CITY OF ALBUQUERQUE

Re: Peter Piper Pizza
1000 Juan Tabo Blvd NE
Traffic Circulation Layout
Architect's Stamp dated 03-22-17 (J22-D012D)

DRAINAGE AND TRANSPORTATION INFORMATION SHEET (REV 09/2015)

sheet:
TCL

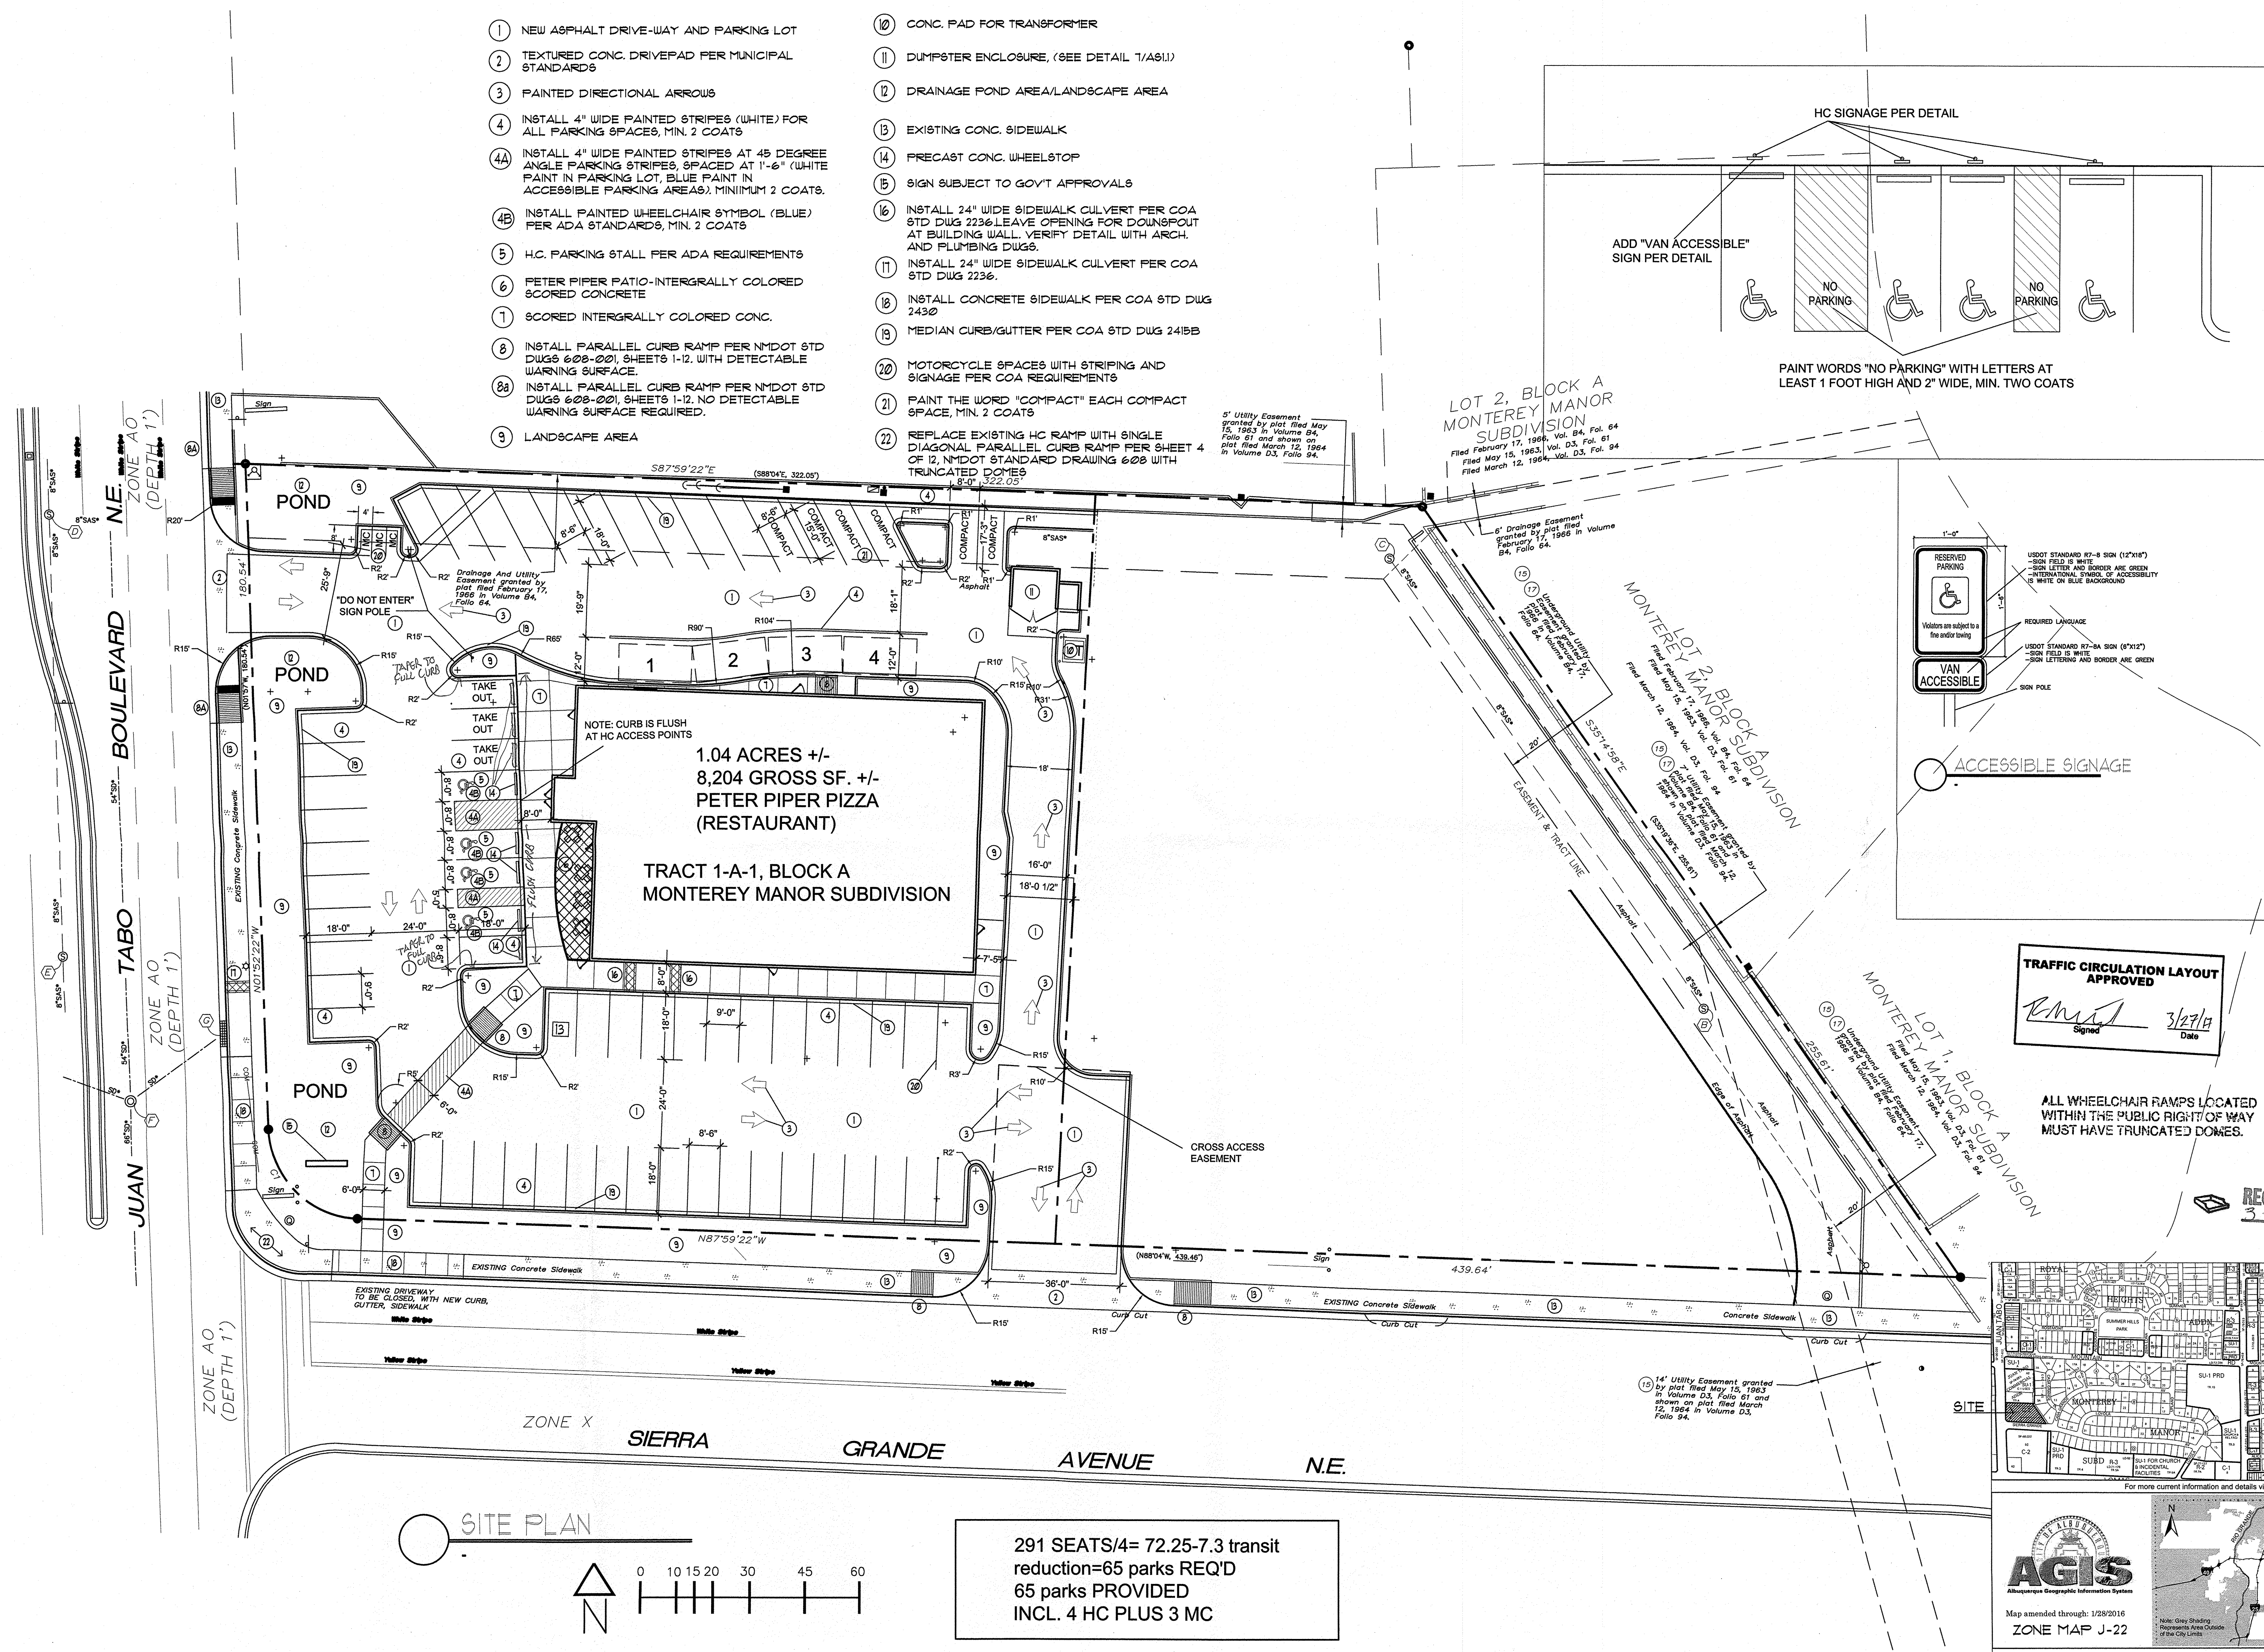
ALL WHEELCHAIR RAMPS LOCATED WITHIN THE PUBLIC RIGHT OF WAY MUST HAVE TRUNCATED DOMES.
